Drawing Title
COVER SHEET

PROPOSED MIXED USE DEVELOPMENT

47-50 THE ESPLANADE ETTALONG BEACH

S75W SUBMISSION

Drawing Title
**LEVEL 01
FLOOR PLAN**

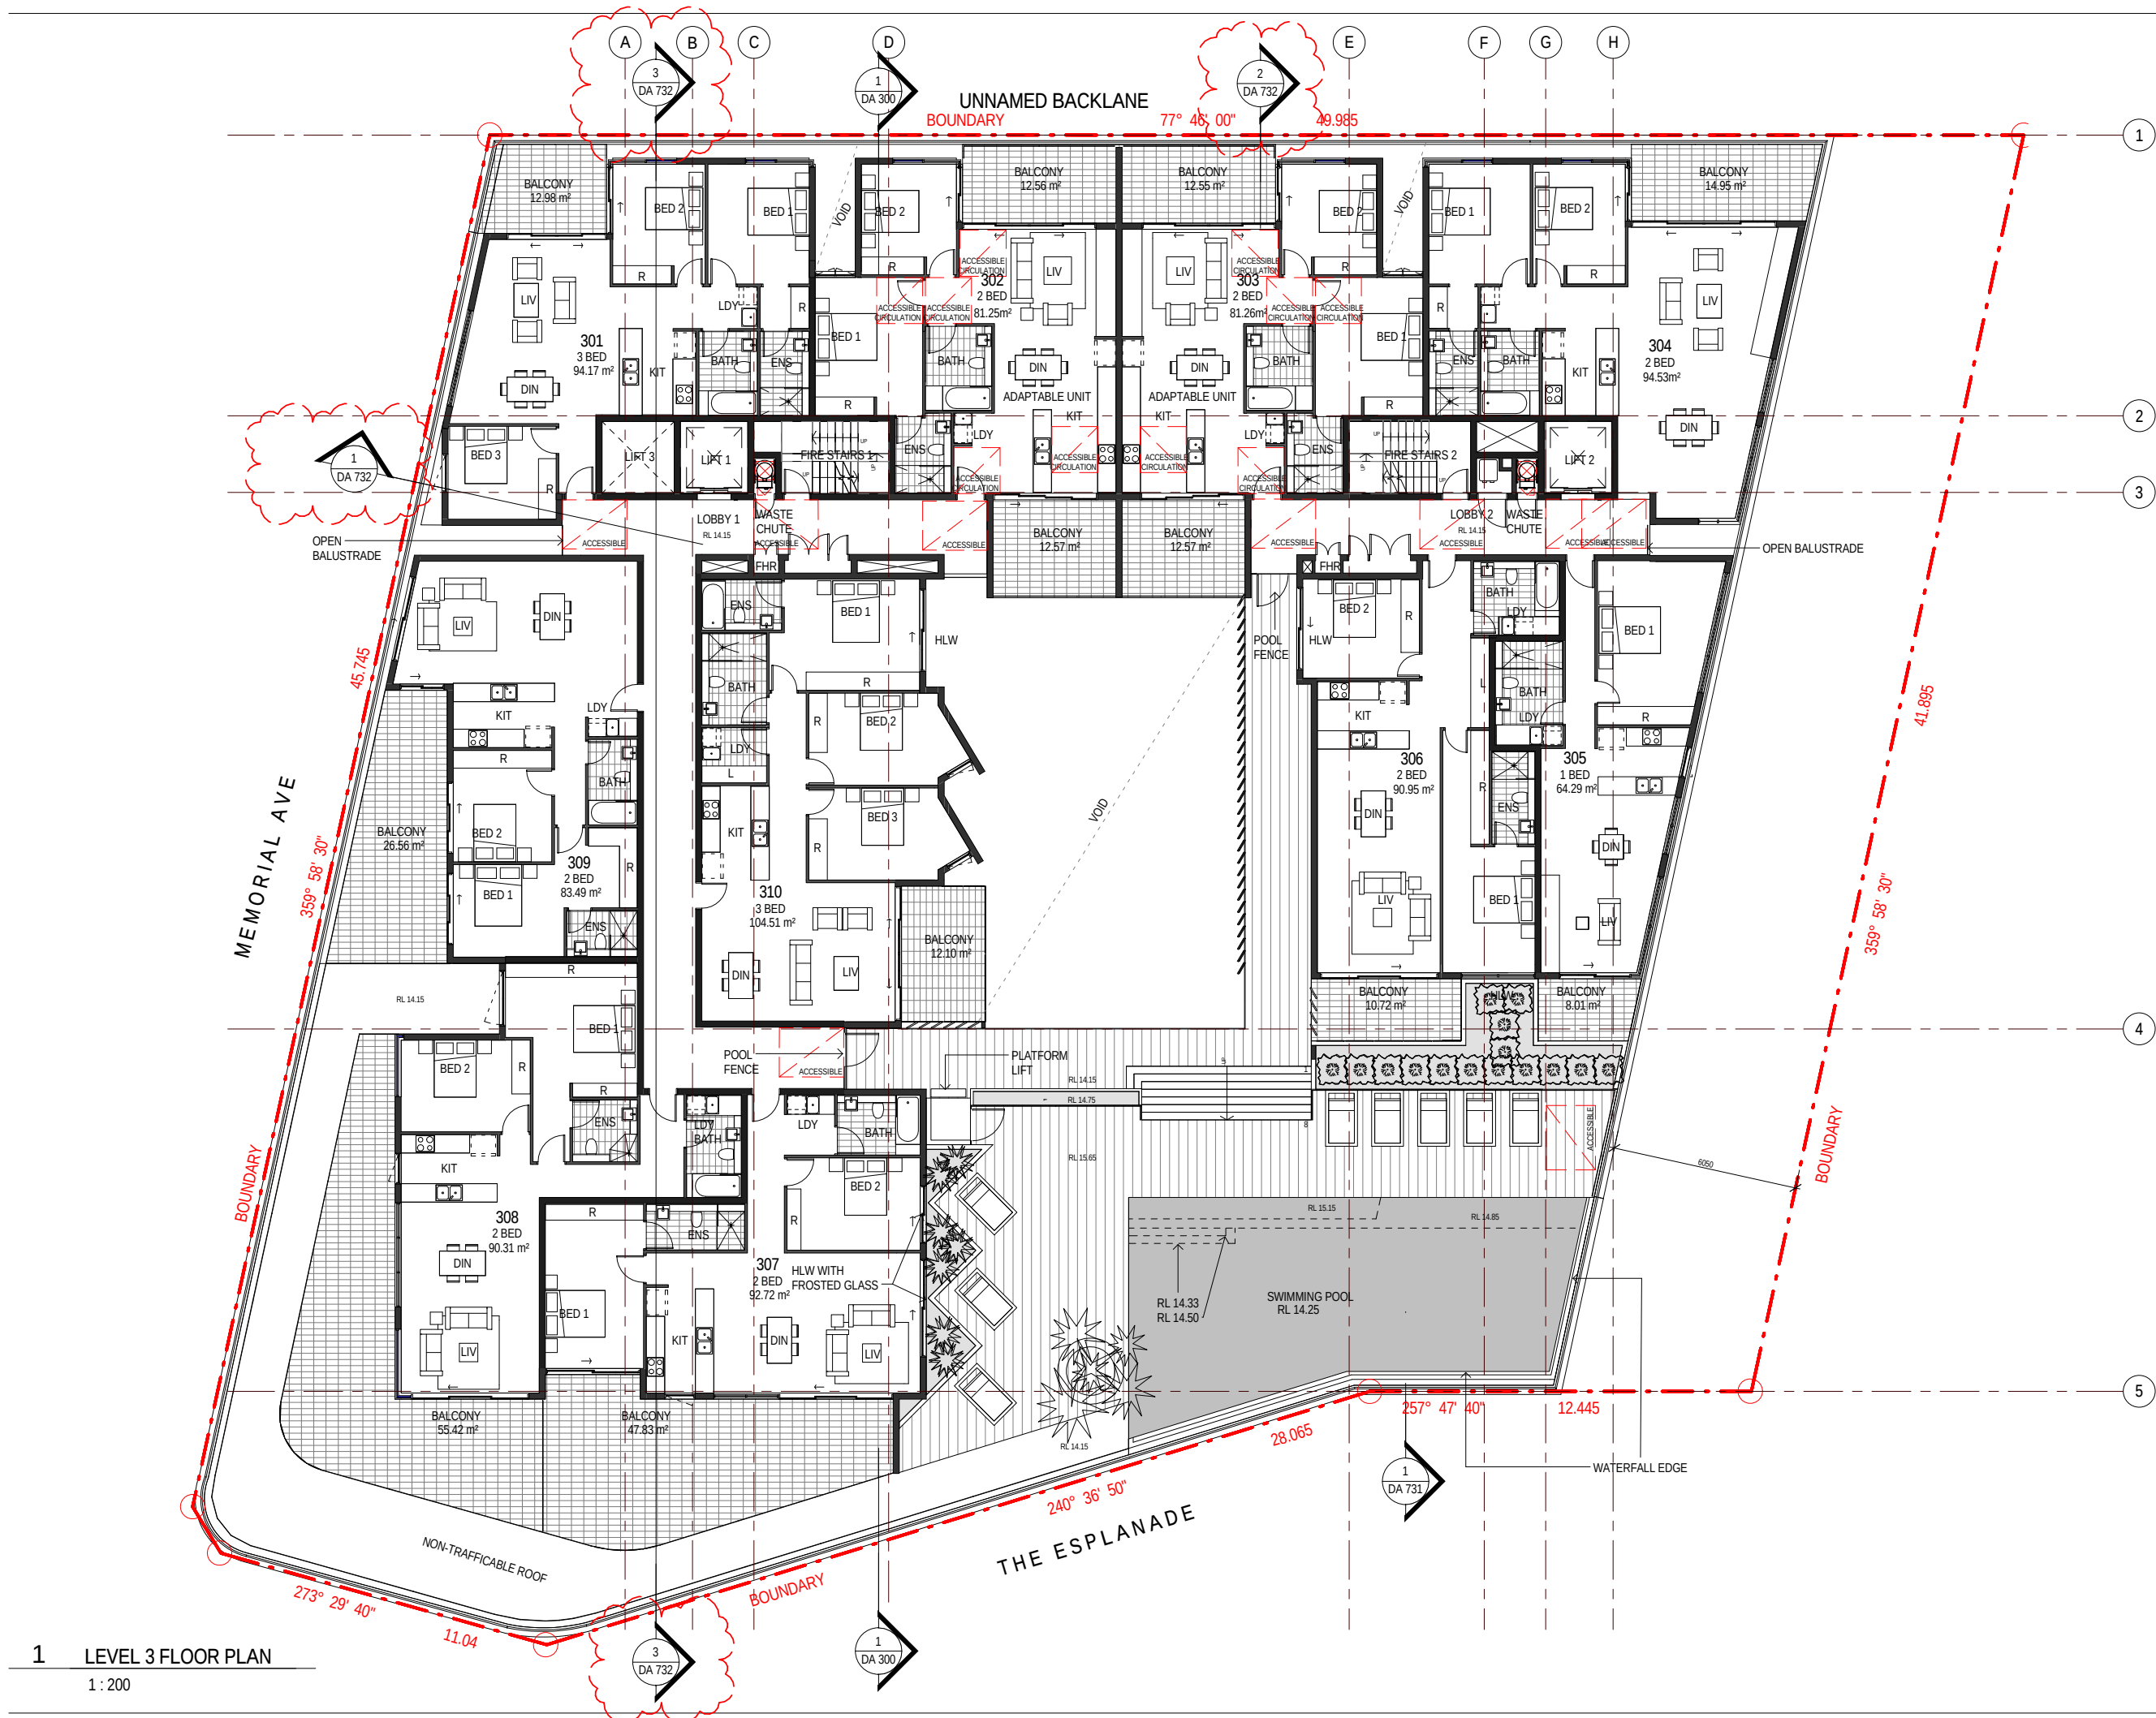
- UNIT 101 AREAS REVISED
- LIFT03 ADDED / LIFT01 RELOCATED
- SECTION LINE RELOCATED
- LIFT CORE /WASTE SHAFT & RECYCLE BIN ROOM REVISED
- SIGHTLINE DIAGRAM MARKERS ADDED

1 LEVEL 3 FLOOR PLAN
1 : 200

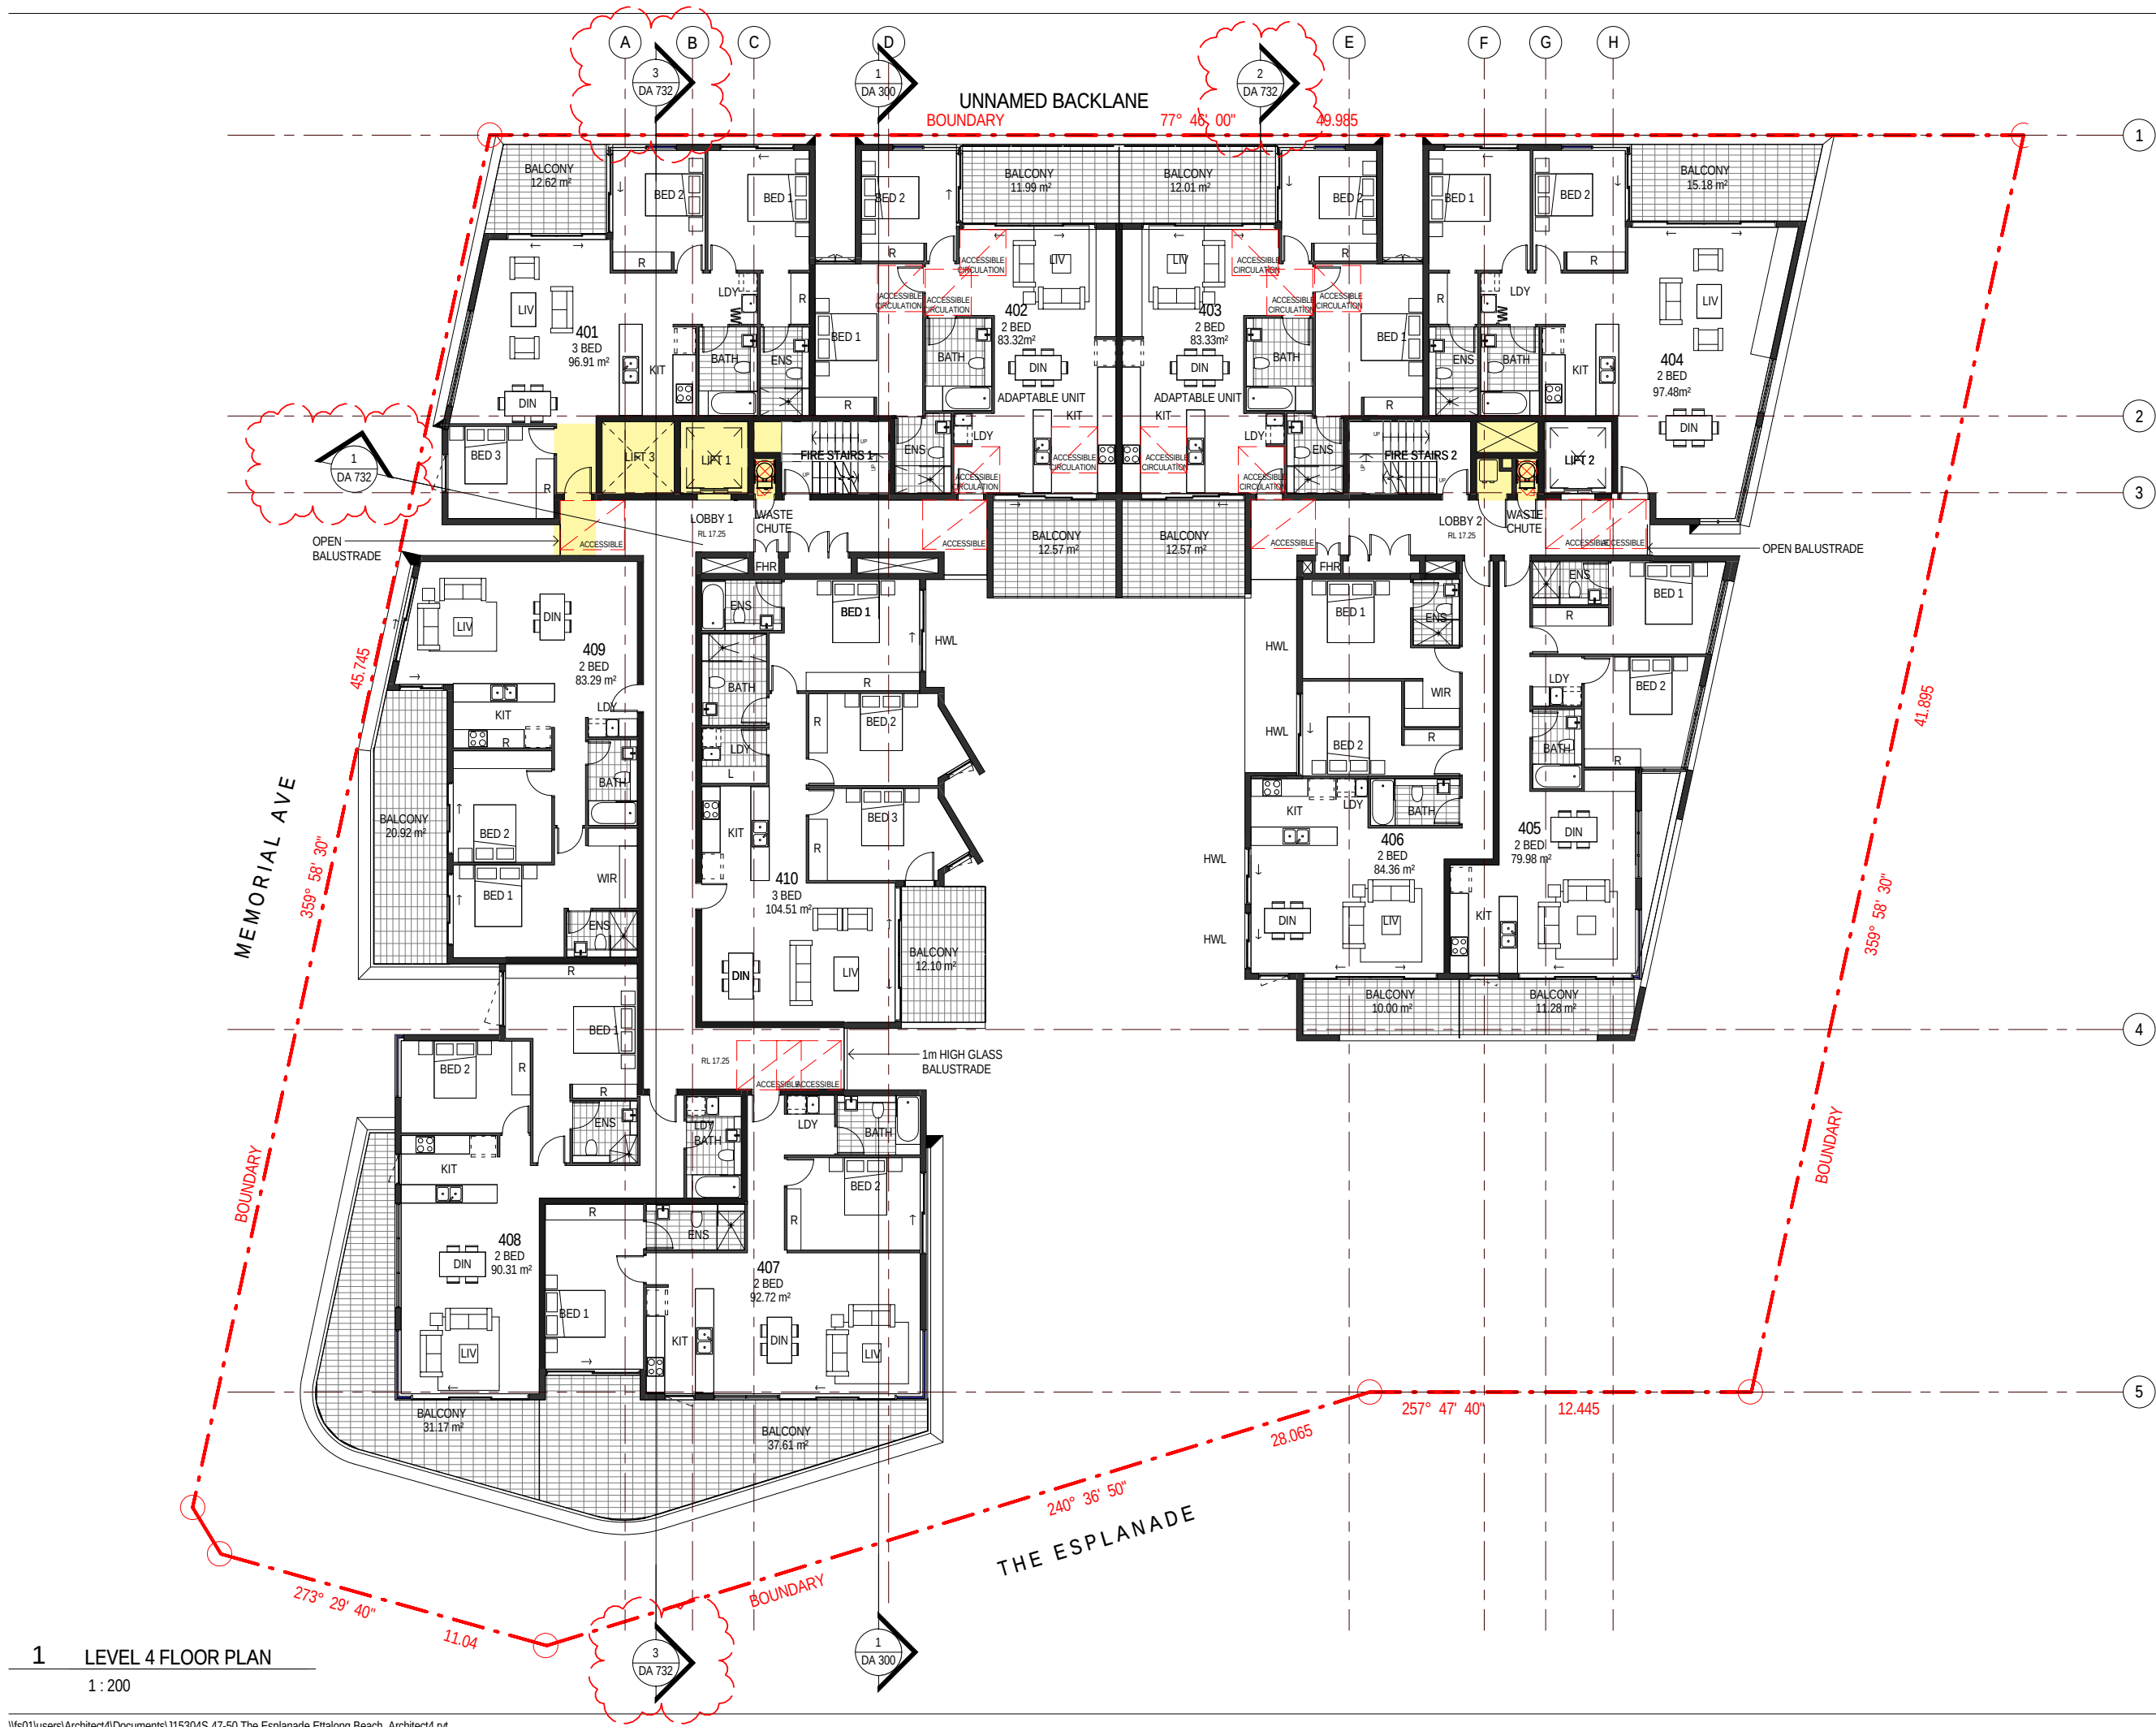
- UNIT 401 AREA REVISED
- UNIT 401 BED 3 WALL REVISED
- LIFT03 ADDED / LIFT01 RELOCATED
- LIFT CORE / WASTE SHAFT & RECYCLE BIN ROOM REVISED
- SIGHTLINE DIAGRAM MARKERS ADDED

Drawing Title
**LEVEL 04
FLOOR PLAN**

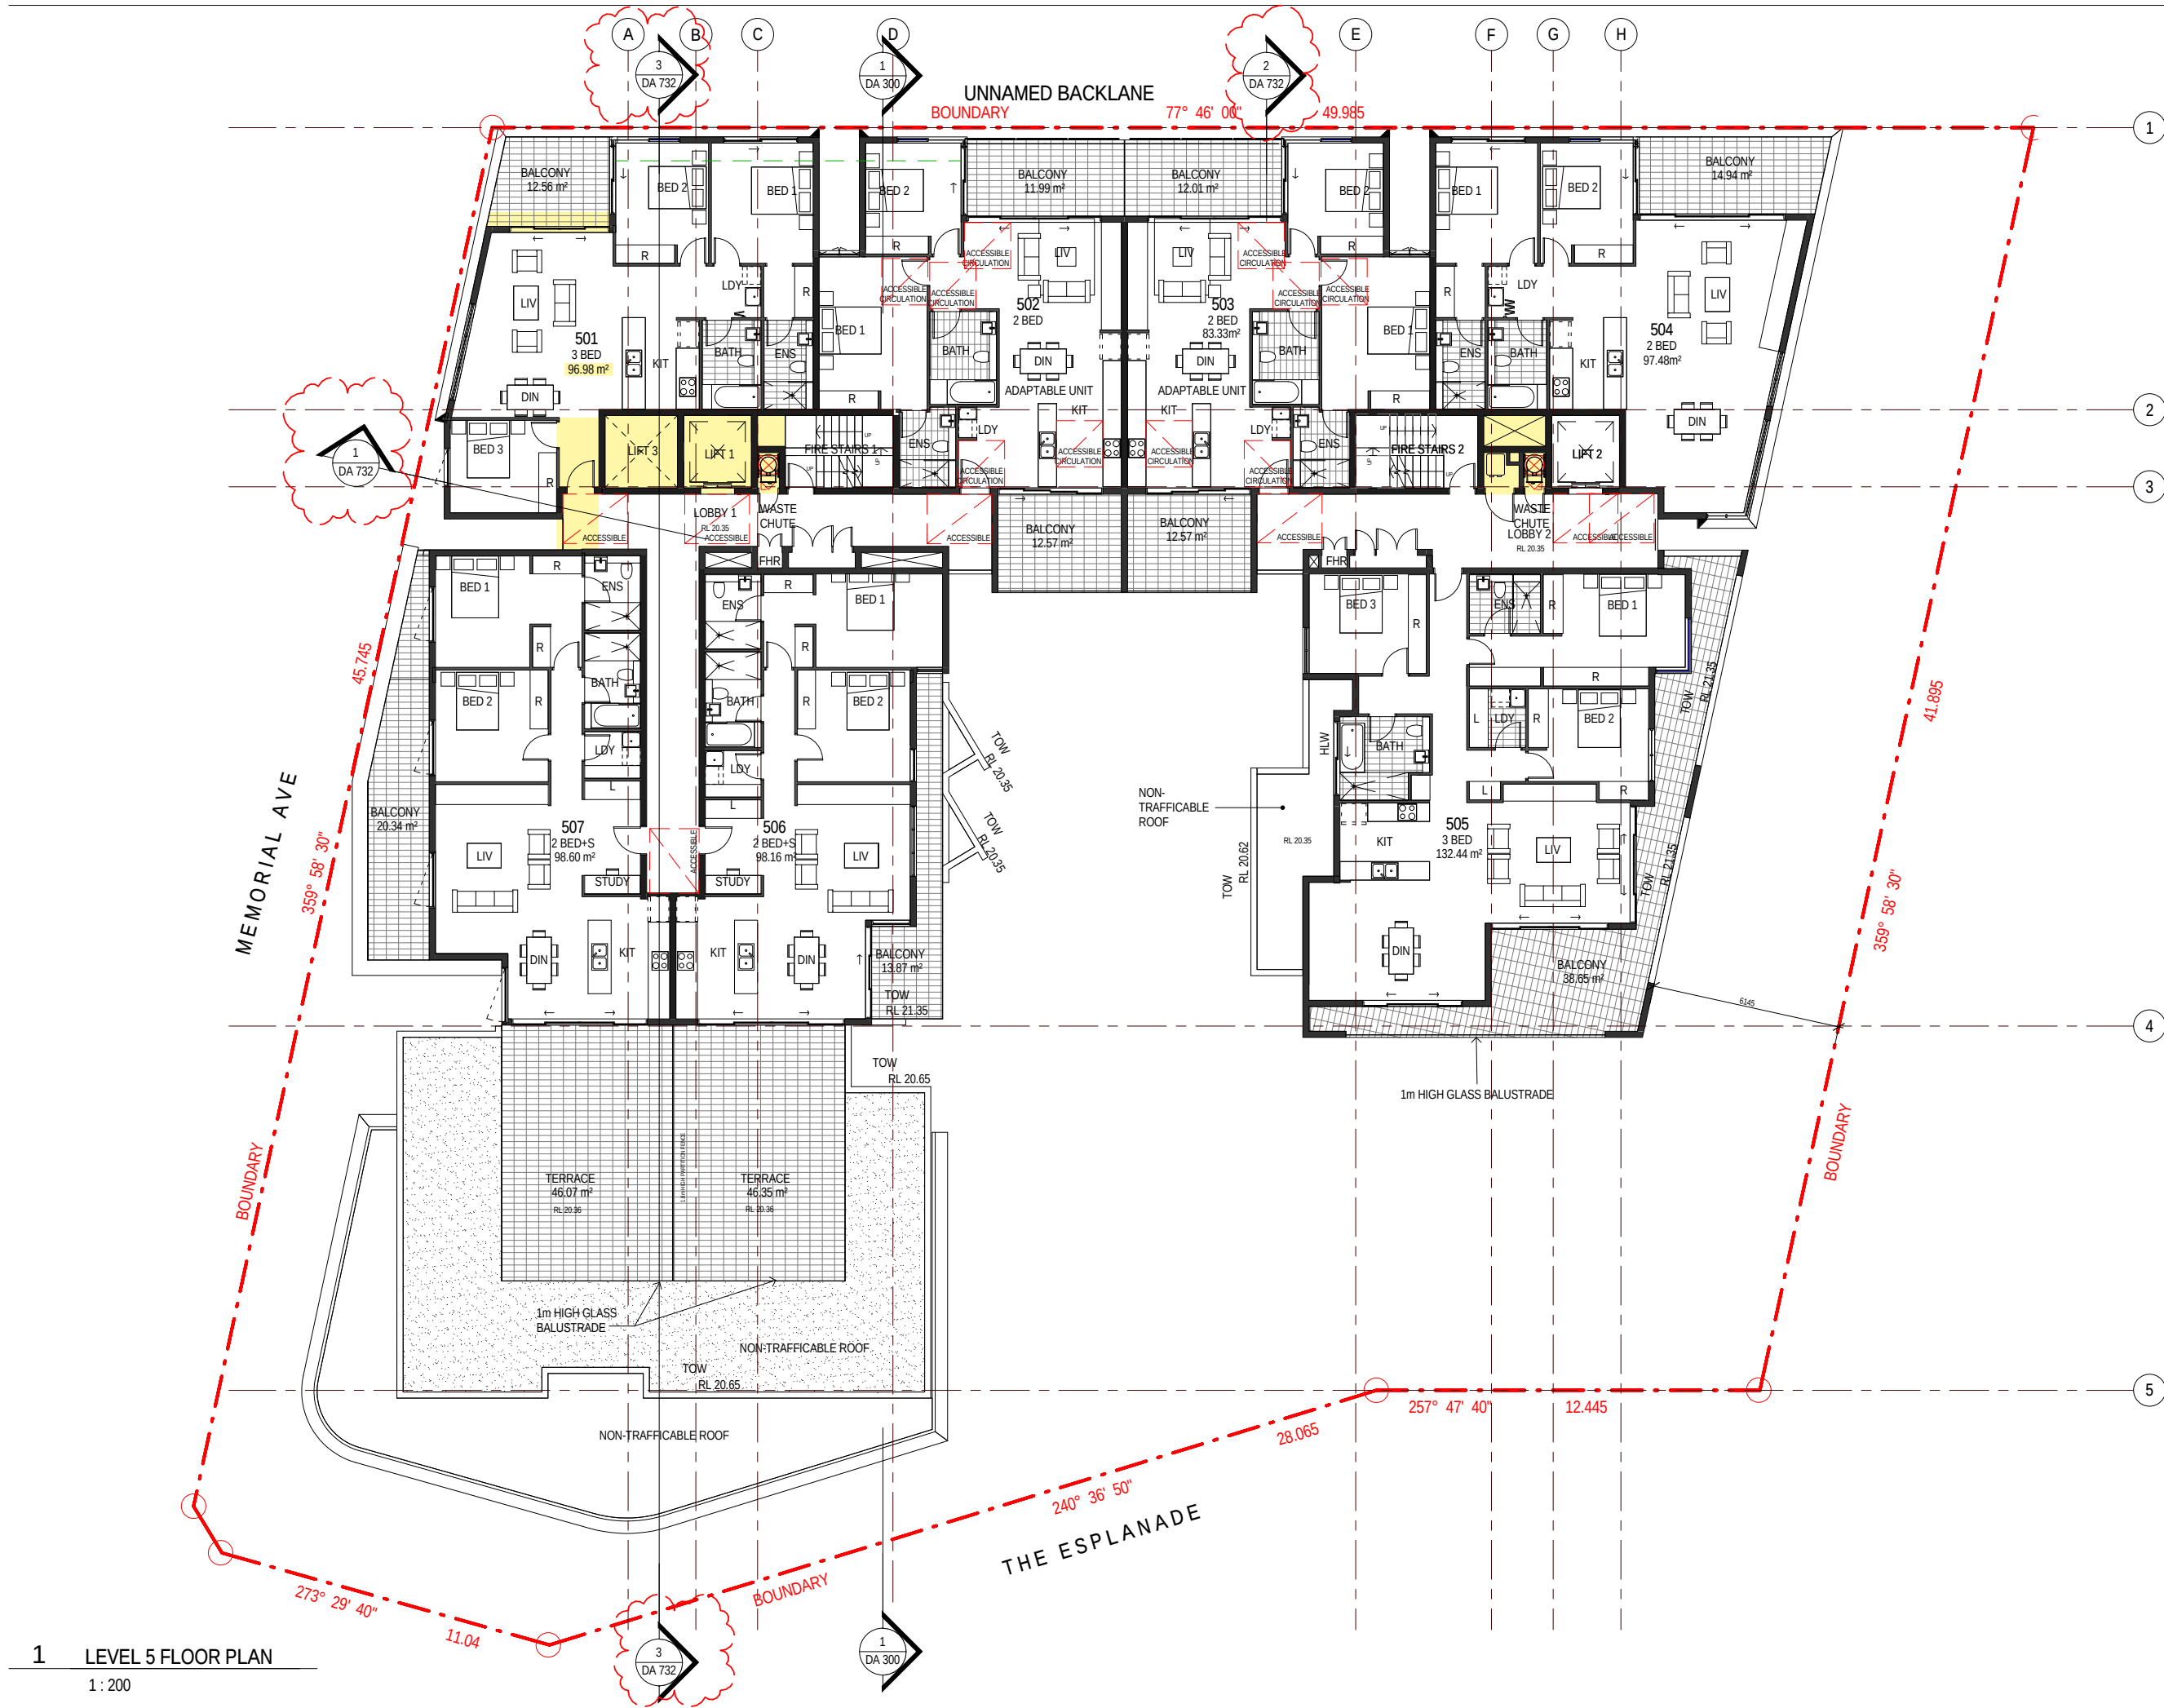
- UNIT 401 AREA REVISED
- UNIT 401 BED 3 WALL REVISED
- LIFT03 ADDED / LIFT01 RELOCATED
- LIFT CORE / WASTE SHAFT & RECYCLE BIN ROOM REVISED
- SIGHTLINE DIAGRAM MARKERS ADDED
